Prairie Island Nuclear Generating Plant

Response to the SER and TER for the 3rd 10-Year Inservice
Testing (IST) Program and Submittal of Revision 3 of the
3rd 10-Year IST Program to the Requirements of ASME Section XI

PRAIRIE ISLAND NUCLEAR GENERATING PLANT
INSERVICE TESTING PROGRAM REQUESTS FOR RELIEF
AND REPLY TO NRC SERs/TER LETTERS DATED DECEMBER 8, 1993
AND MARCH 15, 1994

Request for Relief #17
Figure 1

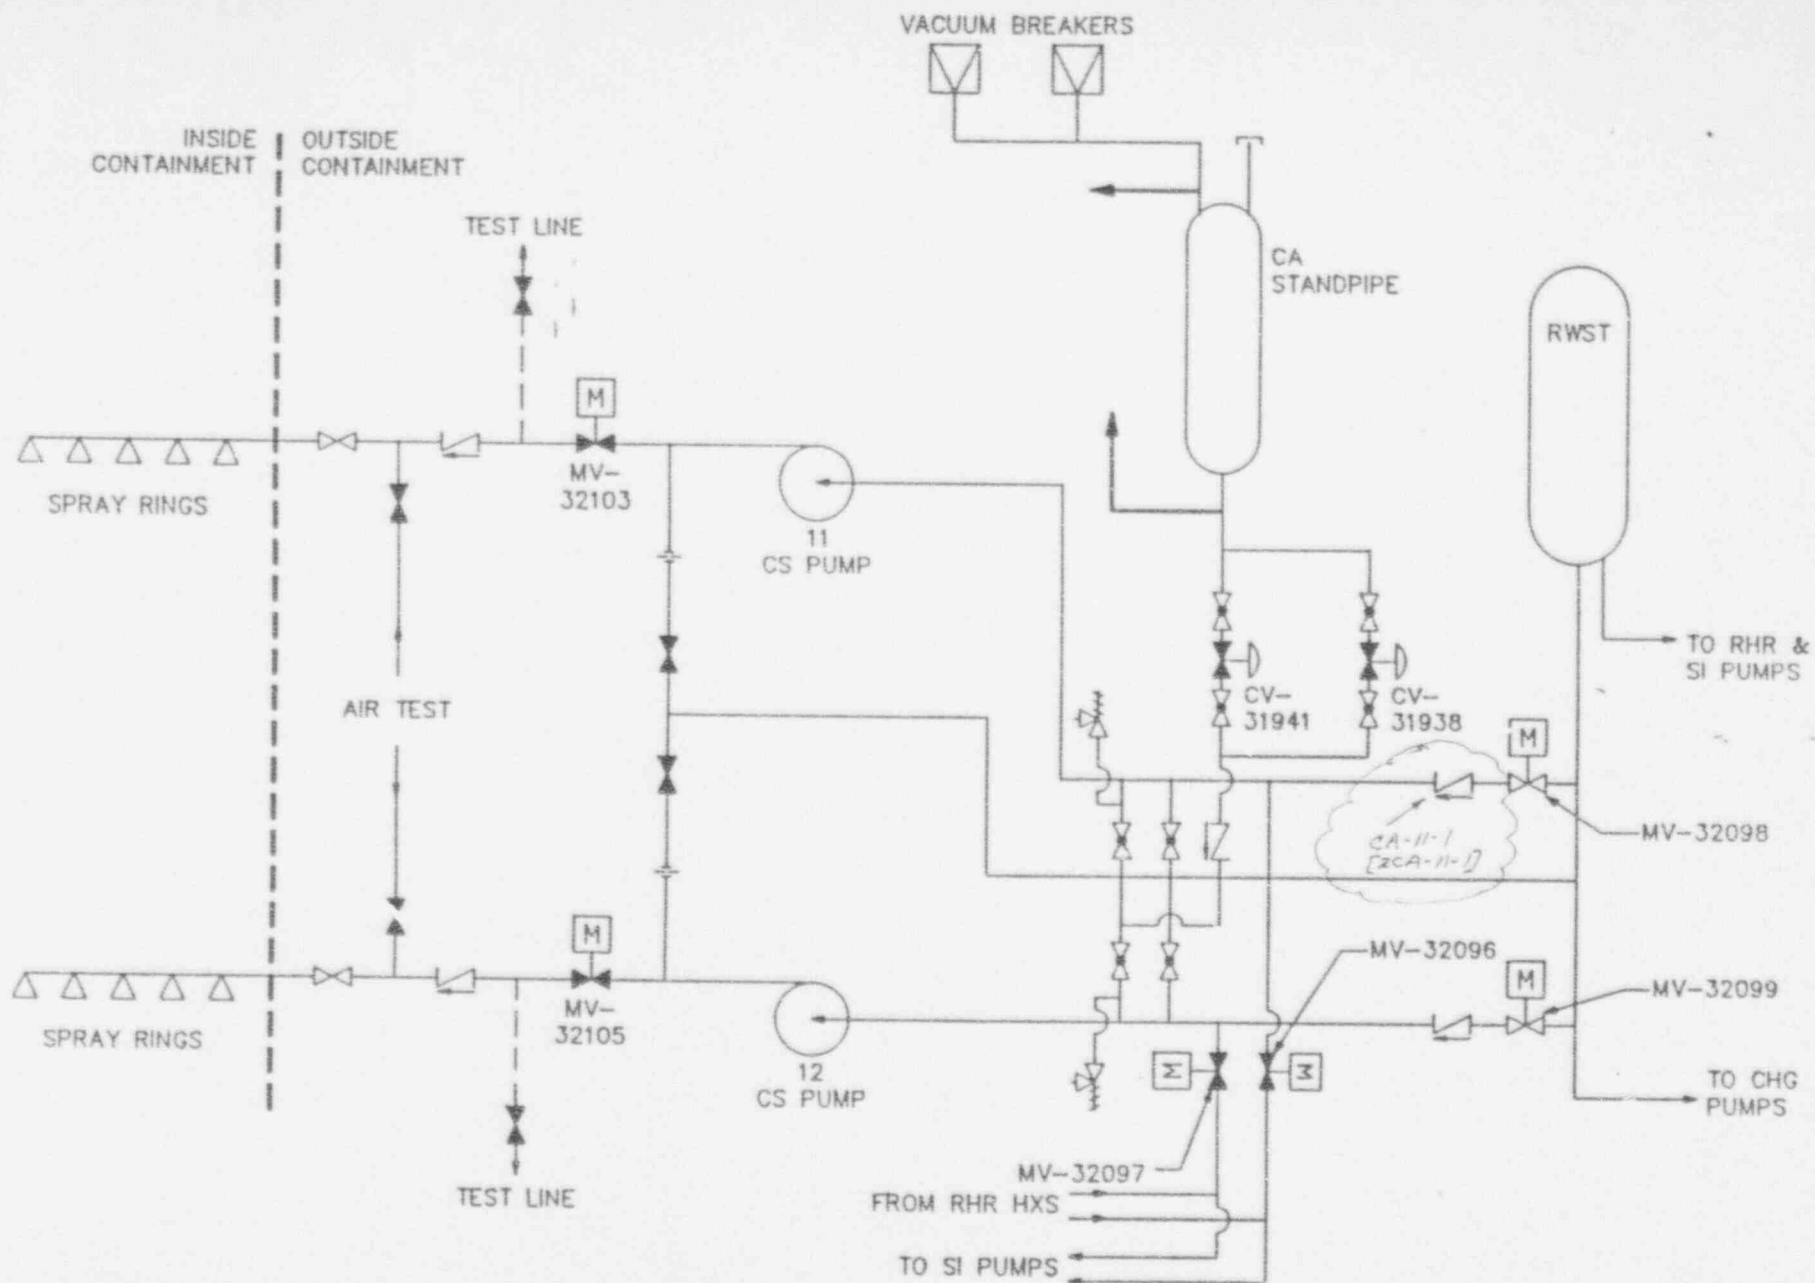
COMPONENTS: CA-11-1, [2CA-11-1] Caustic Addition to Unit 1, [Unit 2]
Containment Spray Pump Suction Check Valve (See Figure 1)

ALTERNATIVE TESTING: It is requested that the disassembly and inspection of CA-11-1 and 2CA-11-1 be extended to a 8 year frequency in lieu of disassembly every refueling. 2CA-11-1 will be disassembled and inspected during the Unit 2 spring 1995 refueling outage to reassure the position stated below on valve degradation is accurate.

BASIS FOR RELIEF: CA-11-1 and 2CA-11-1 are 4" stainless steel swing check valves located on the suction of the containment spray pumps. The valves are sized to minimize the flow restriction in the gravity drained caustic addition standpipe outlet piping. The design accident flow, approximately 70 gpm, is not sufficient to exercise the valve to the full open position. Engineering calculations show that approximately 300 gpm is required to fully open the valve.

It is not possible to test the obturator travel of CA-11-1 or 2CA-11-1 to the full open position quarterly, at cold shutdown or during refueling due to piping limitations in the sizes of vents and drains. The maximum flow estimated through the vent and drain piping is 5 gpm.

Request for Relief #18
Figure 1

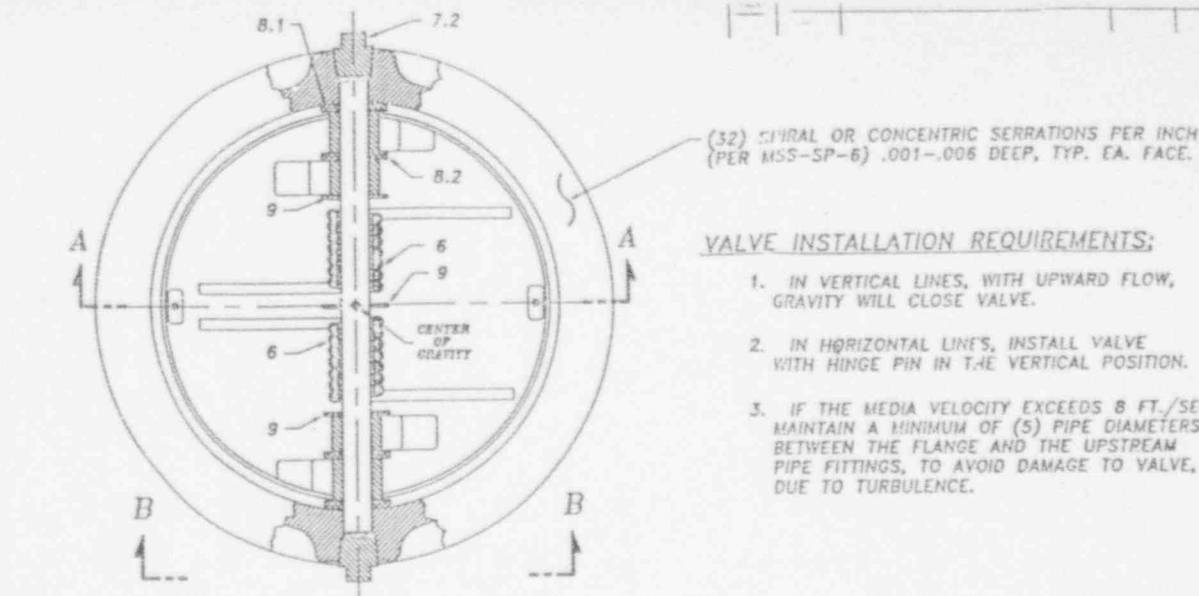
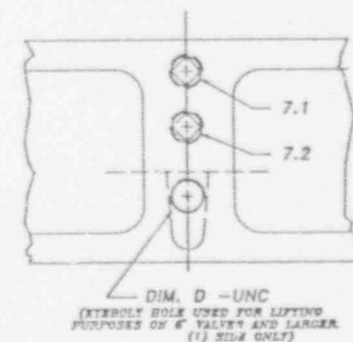
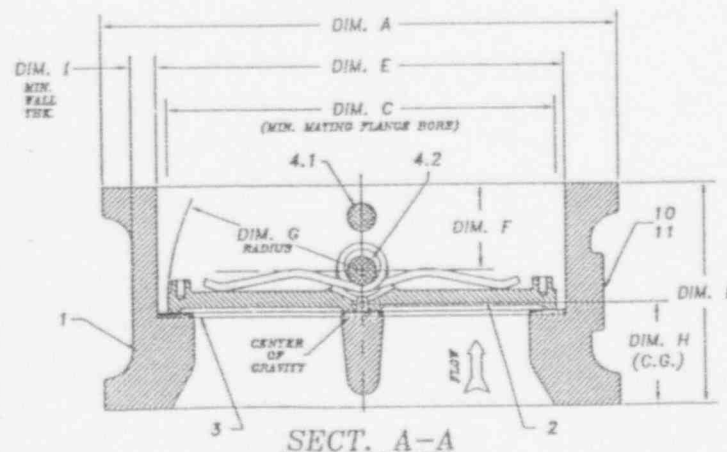
COMPONENTS: CL-43-2, CL-43-3 and 2CL-43-2; 12, 121 and 22 Safety Related Service Water Pump Discharge Check Valves. (See Figure 3)

ALTERNATIVE TESTING: CL-43-2, CL-43-3 and 2CL-43-2 will be partial-stroke exercised on a quarterly frequency and full-stroke exercised to the open position on a yearly basis. Full-stroke exercising will be performed during the period of the year when service water flow is at its nominal peak. The flow during the full stroke exercise will not necessarily be the accident condition flow, rather the flow will be the nominal maximum attainable flow at the peak of the seasonal flow changes. The full-stroke exercise flow will be greater than the minimum flow value to assure the valve is full open provided by the valve manufacturer.

The valve design, being a dual plate wafer check valve (See Figures 1 and 2), is fully open at flows significantly lower than the design accident flow. The flow required to fully open the valve is directly related to the spring force. The design of the valve utilizes the spring to assist in closing the valve (the spring is relatively weak when compared to the opening force). Any flow in excess of that required to fully open the valve only increases the pressure drop across the valve. The design accident flow for these valves is 70 percent greater than the minimum flow to verify the valve is full open. Testing of the valve at a flow significantly beyond the minimum flow provides no usable information relating to valve degradation. Testing of the obturator travel to the closed position, which is performed quarterly, provides the meaningful data as to the status of the valve internals.
